ENGINE - HP TURBINE ROTOR AND STATOR ASSEMBLY - INTRODUCE A REVISED STAGE 2 BLADE
RETAINING PLATE - CATEGORY CODE 7 - MOD.ENG-72-0028

V2500-ENG-72-0028

Location of the stage 2 HPT blade retaining plate
Fig.1

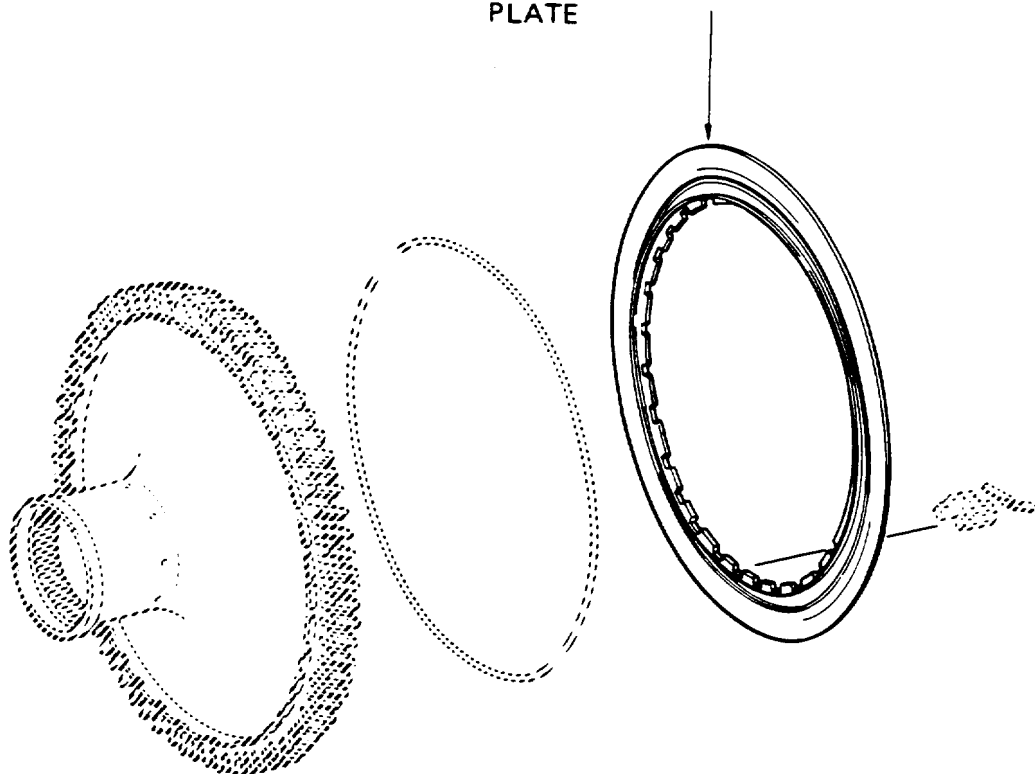
- (1) Install the 2A1813 stage 2 Blade Retaining Plate (1 off) by the approved procedure in Reference (1) Chapter/Section 72-45-30 Assembly. Refer to Figure 1.

REMOVE THE PN 2A0160 STAGE 2
HPT BLADE RETAINING PLATE
(1 Off) AND INSTALL THE PN 2A1813
STAGE 2 HPT BLADE RETAINING
PLATE
